PROPOSED COMPREHENSIVE PLAN AMENDMENT ADDENDUM

ITEM: SSPA 2018-1-1MS

Date of Addendum: September 10, 2019

SITE-SPECIFIC PLAN AMENDMENT 2018-I-1MS STAFF REPORT ADDENDUM

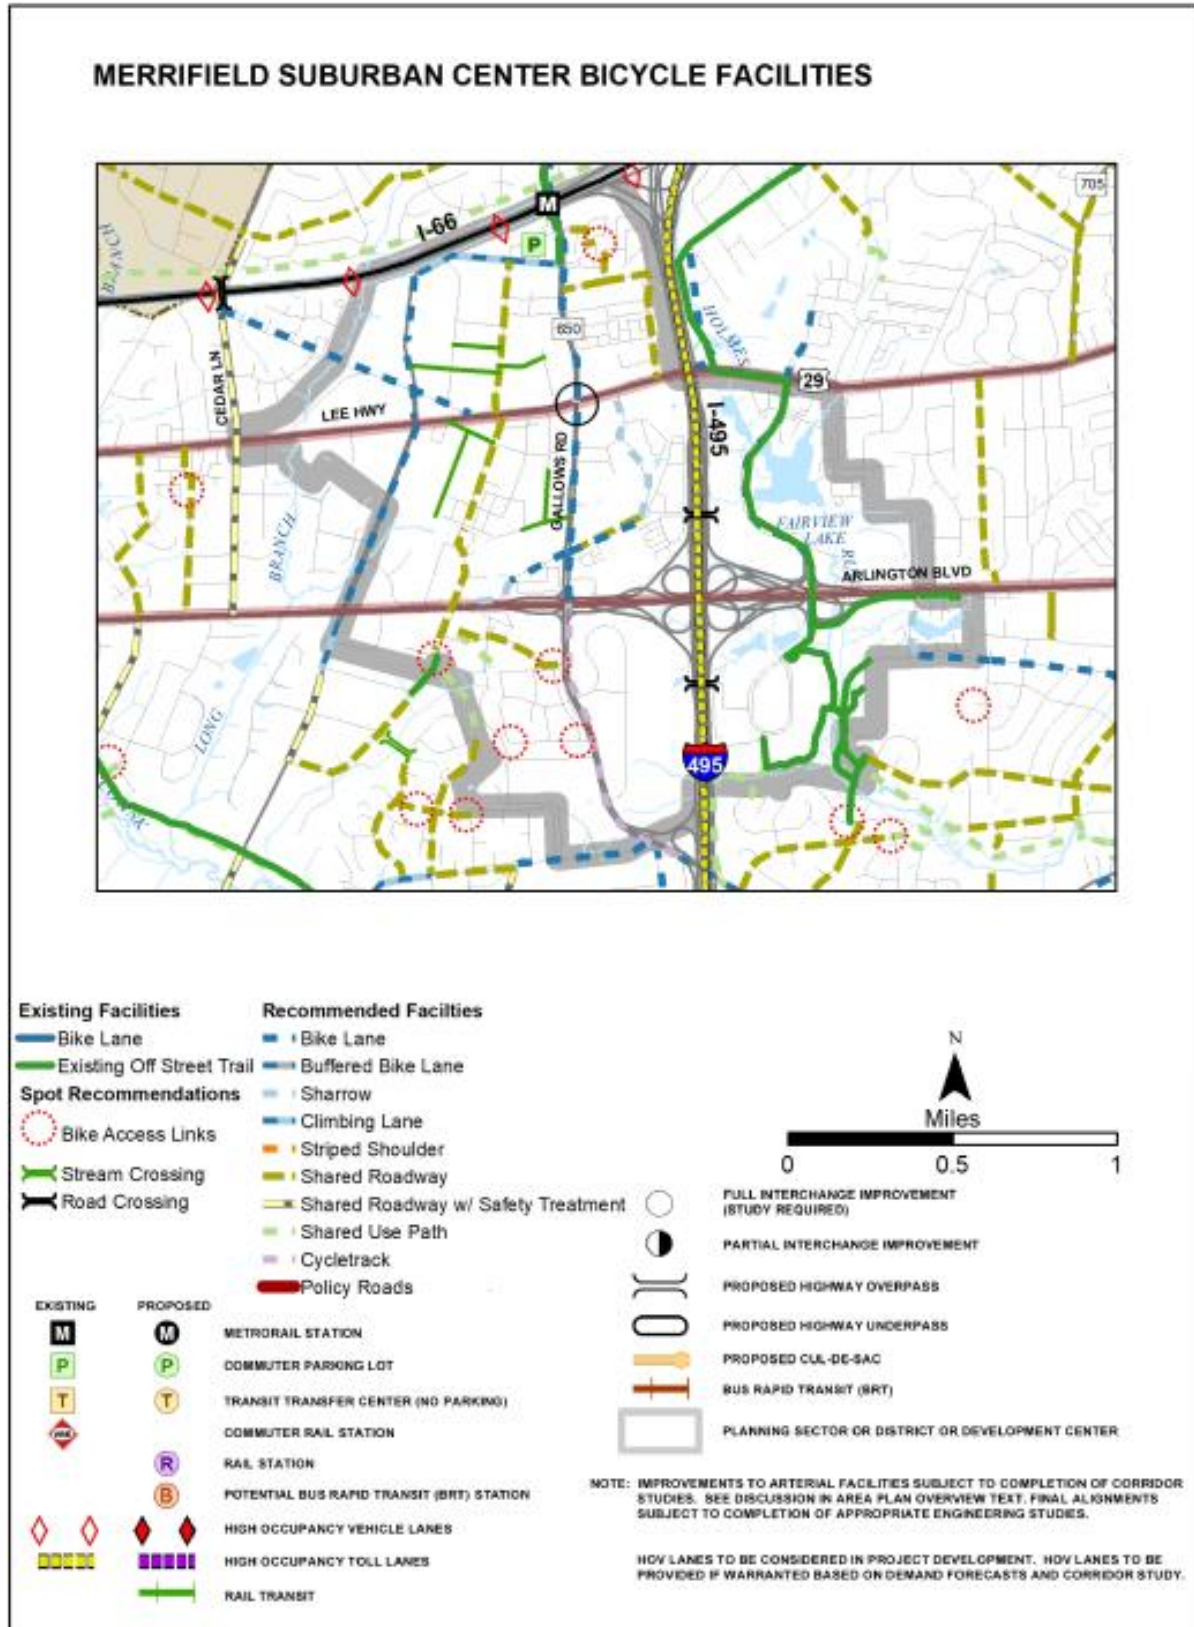
1281 **BICYCLE MASTER PLAN MAP:** Update the elements of the Northeast Quadrant Map for the
 1282 Merrifield Suburban Center, Merrifield inset, to reflect a cycle-track on the east side of Gallows
 1283 Road between the Gallows Road I-495 interchange and the intersection of Gallows Road and
 1284 Route 50.

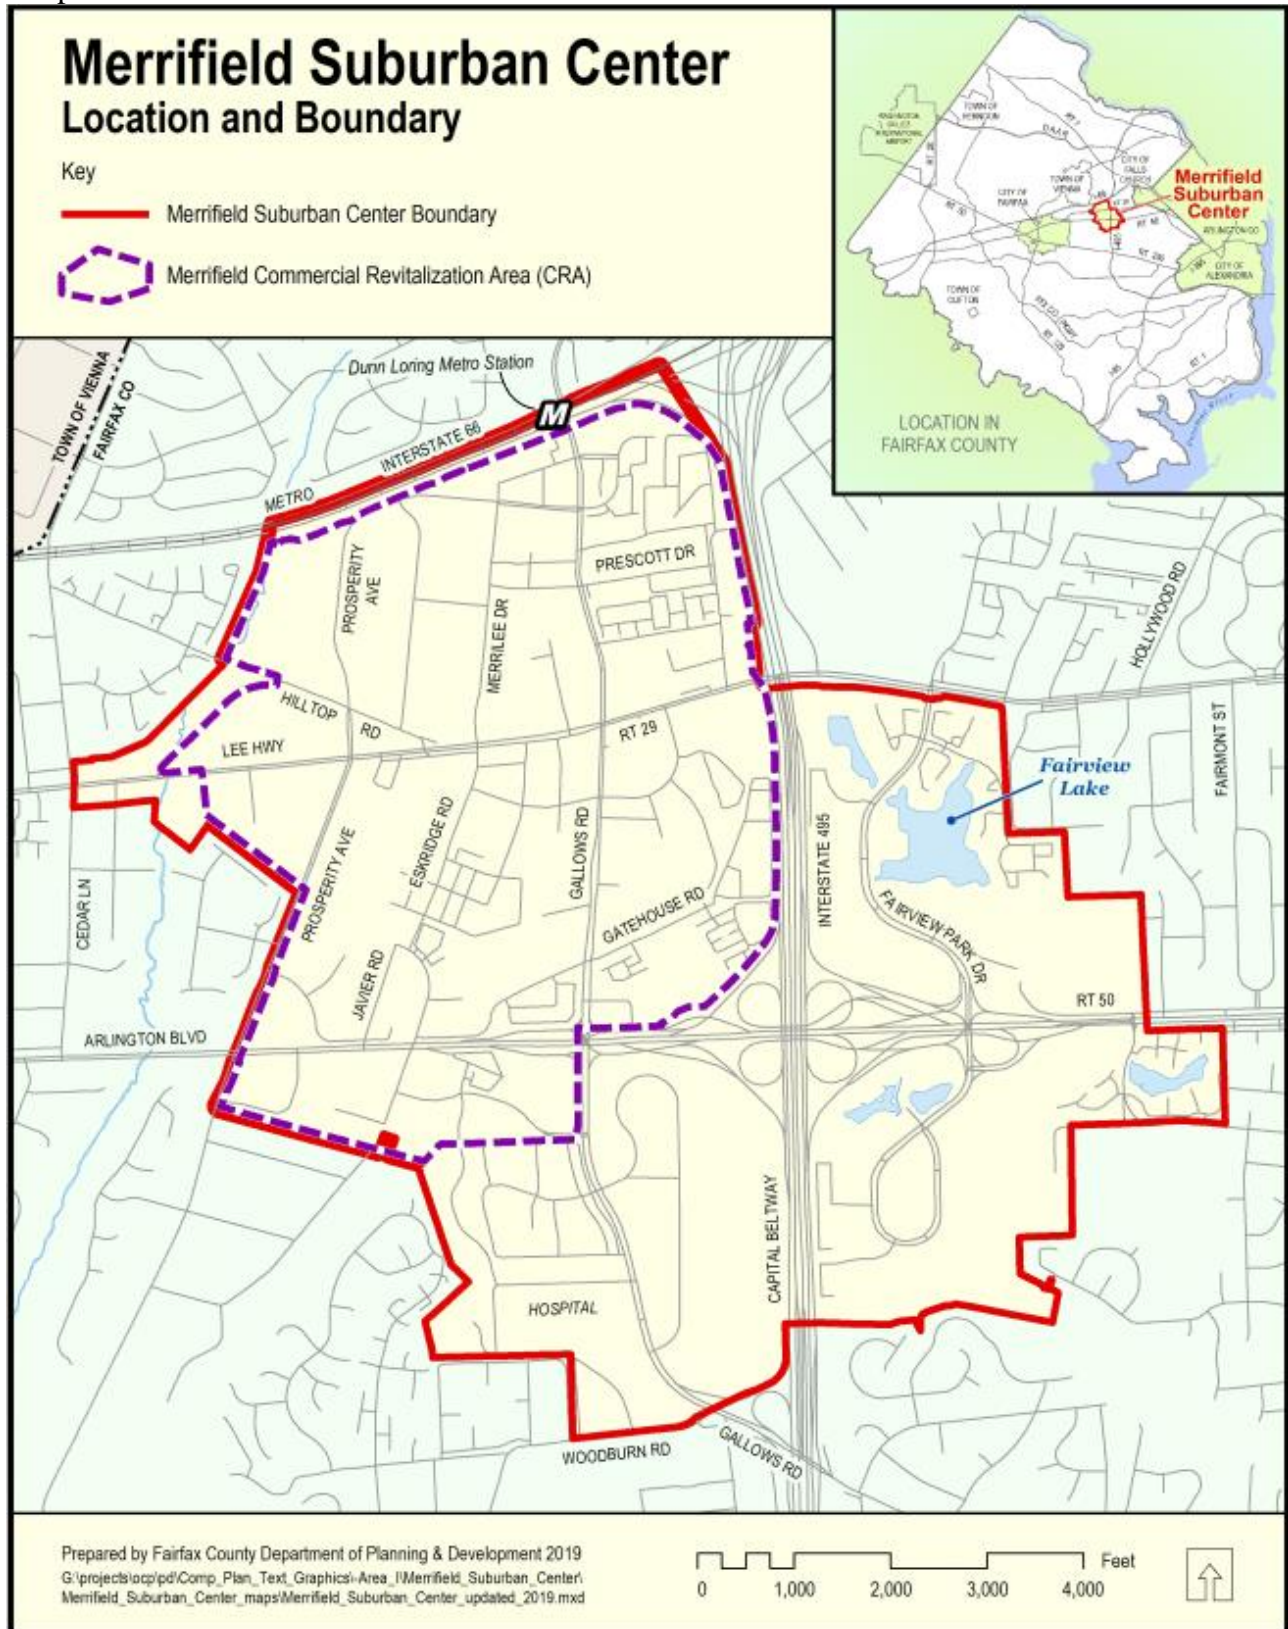
1286 **MODIFY FIGURE:** Fairfax County Comprehensive Plan, 2017 Edition, Area I, Merrifield
1287 Suburban Center, Area-wide Guidance, as amended through July 31, 2018, Figure 1, page 2 to
1288 move the word “HOSPITAL” further south to reflect the accurate location of Inova Fairfax
1289 Hospital.

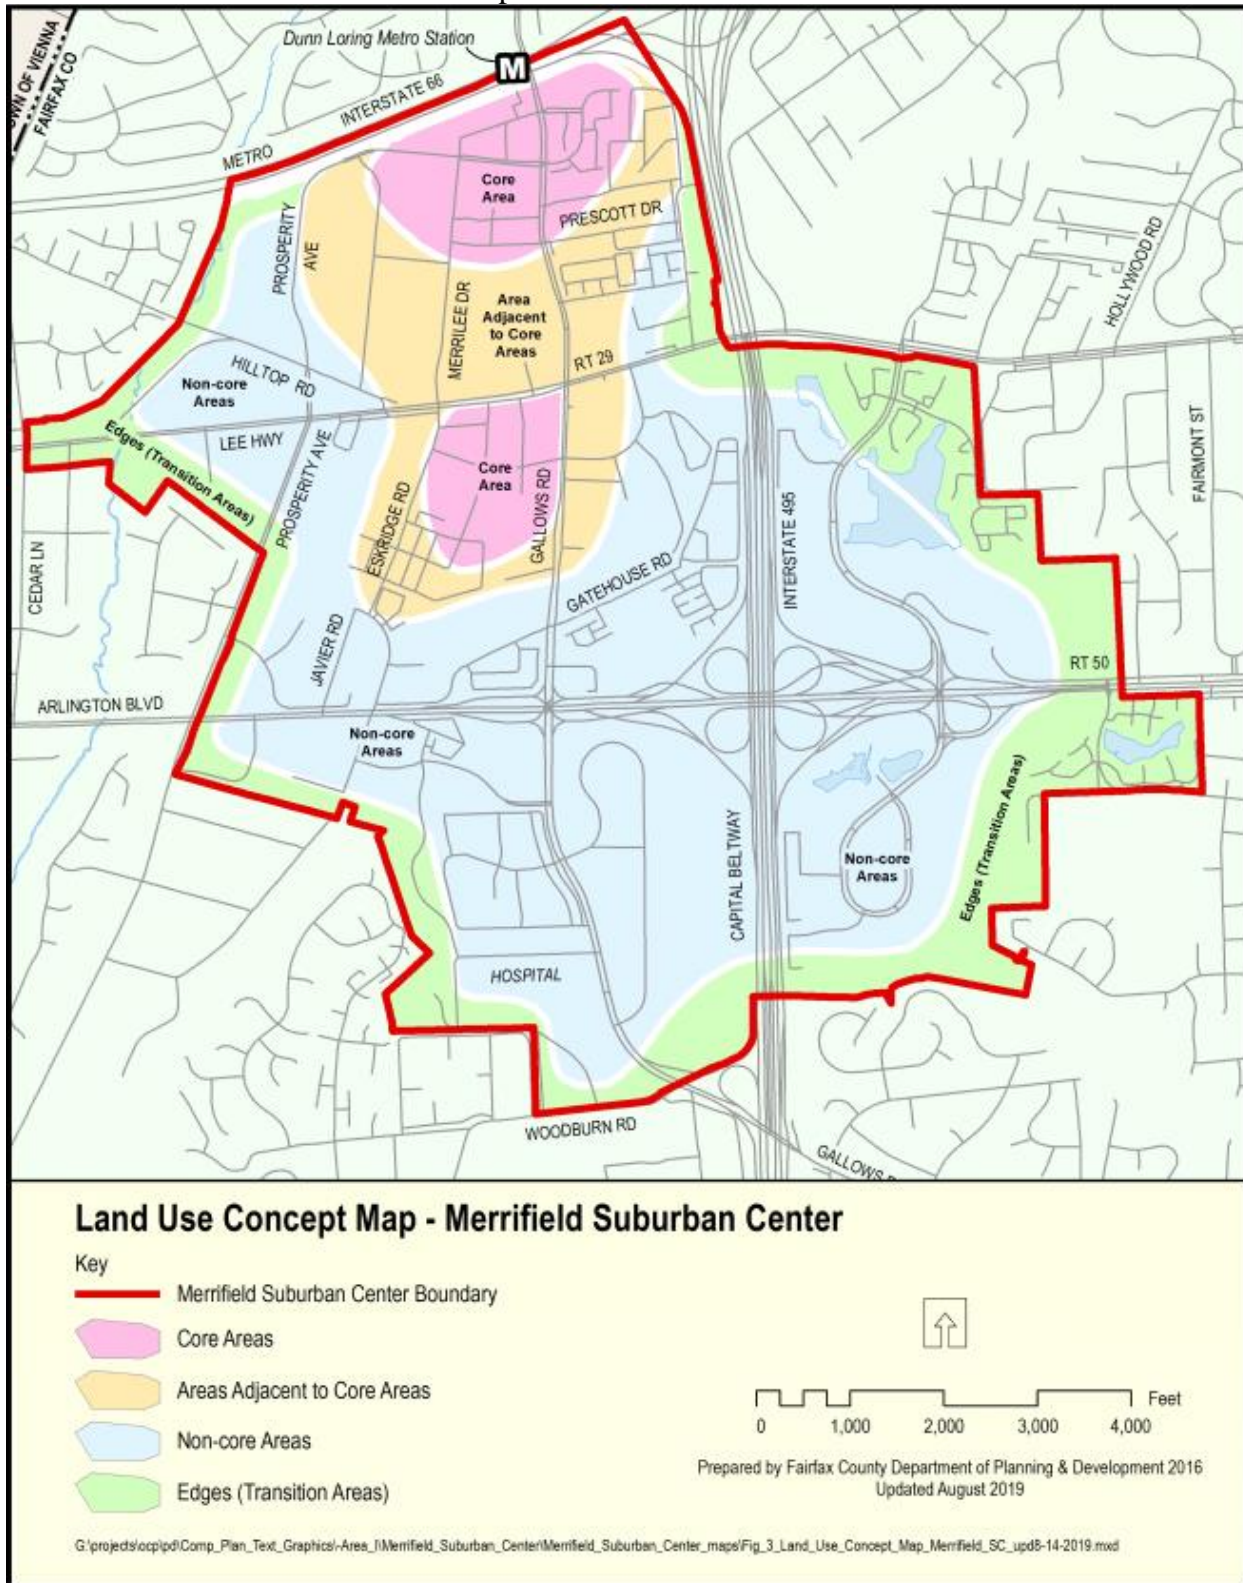
1291 **MODIFY FIGURE:** Fairfax County Comprehensive Plan, 2017 Edition, Area I, Merrifield
 1292 Suburban Center, Area-wide Guidance, as amended through July 31, 2018, Figure 1, page 2;
 1293 Figure 3, page 9; Figure 10, page 28 to move the word “HOSPITAL” further south to reflect the
 1294 accurate location of Inova Fairfax Hospital.

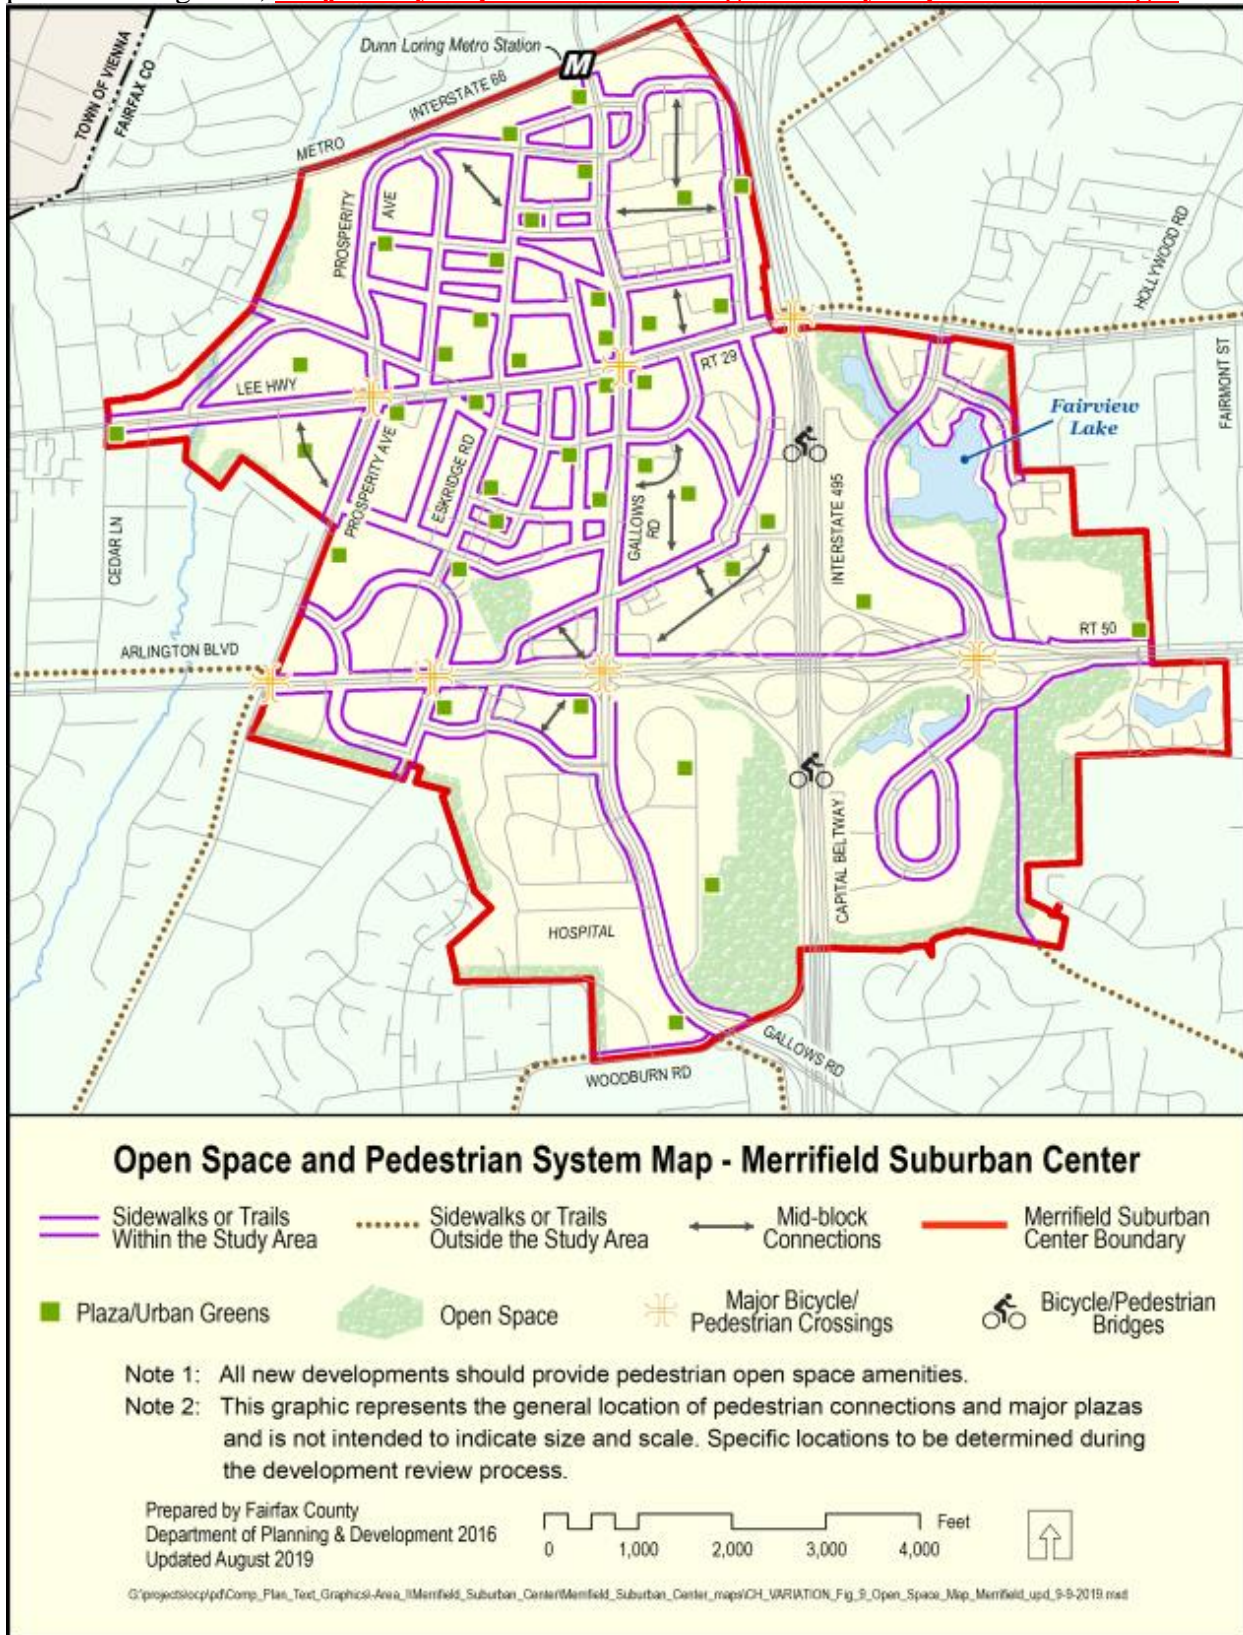
1. Modified Open Space Map to show major bicycle and pedestrian crossings and bridges, including over the Beltway to the north and south of Arlington Boulevard, and at prominent intersections, such as Gallows Road/Arlington Boulevard and Gallows Road/Lee Highway.

REPLACE FIGURE: Fairfax County Comprehensive Plan, 2017 Edition, Area I, Merrifield Suburban Center, Area-wide Guidance, as amended through July 31, 2018, Figure 9, page 24 to modify open space areas and add green squares in Land Unit K and Subunit II to reflect new plazas/urban greens, **- major bicycle/pedestrian crossings and bicycle/pedestrian bridges.**

Building Heights Map - Merrifield Suburban Center

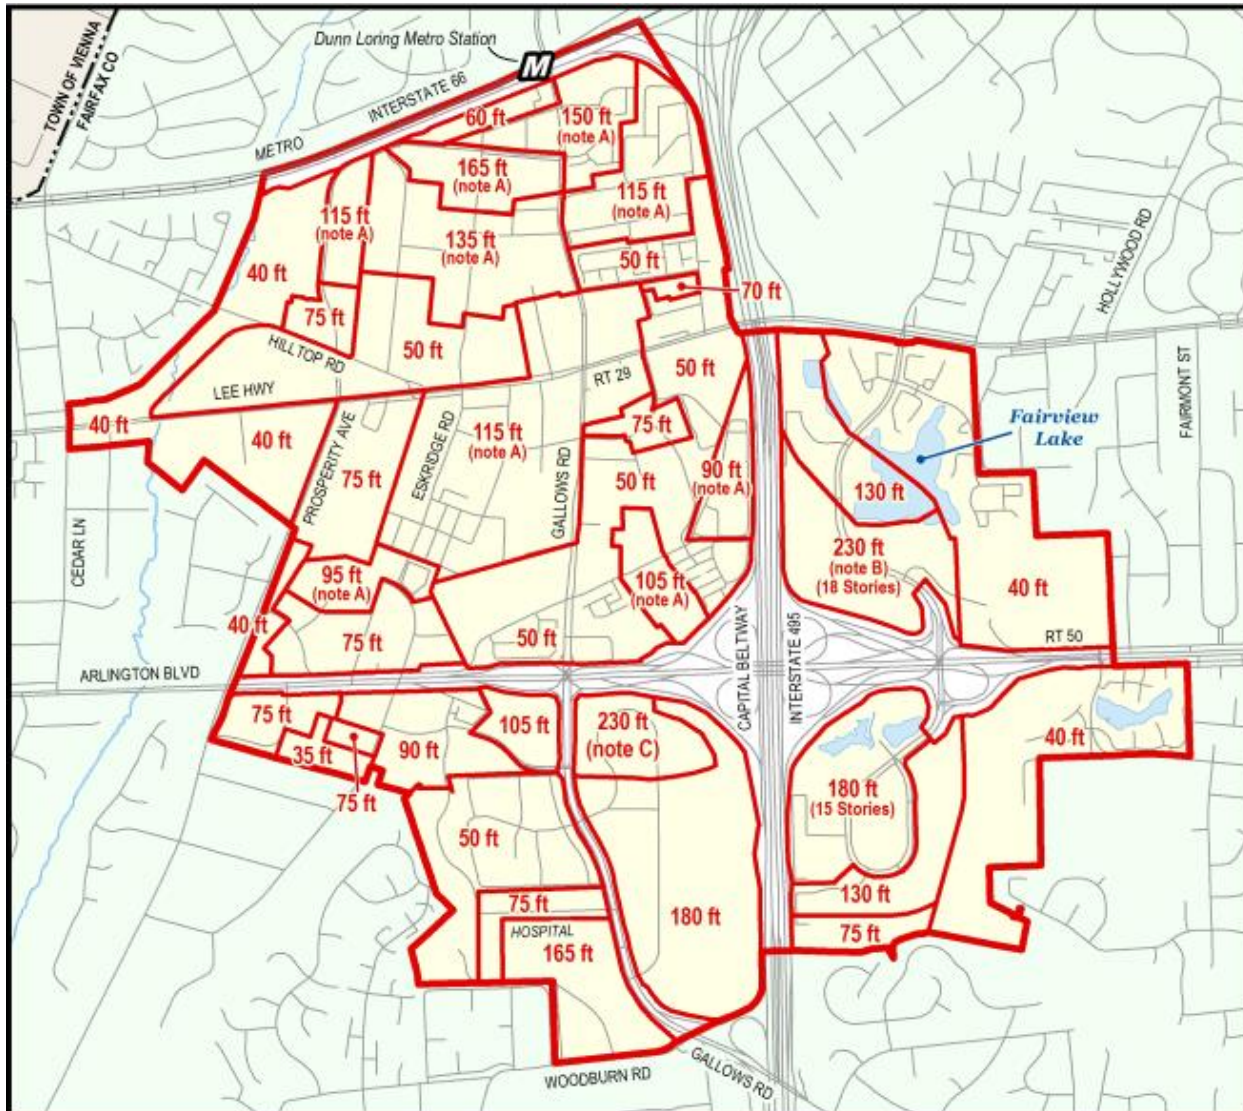
1302 **REPLACE FIGURE:** Fairfax County Comprehensive Plan, 2017 Edition, Area I, Merrifield
 1303 Suburban Center, Area-wide Guidance, as amended through July 31, 2018, Figure 8, Building
 1304 Heights Map to increase maximum building height shown on Land Unit K (in certain areas) from
 1305 180 feet to 230 feet, areas and to move the word “HOSPITAL” further south to reflect the
 1306 accurate location of Inova Fairfax Hospital.
 1307
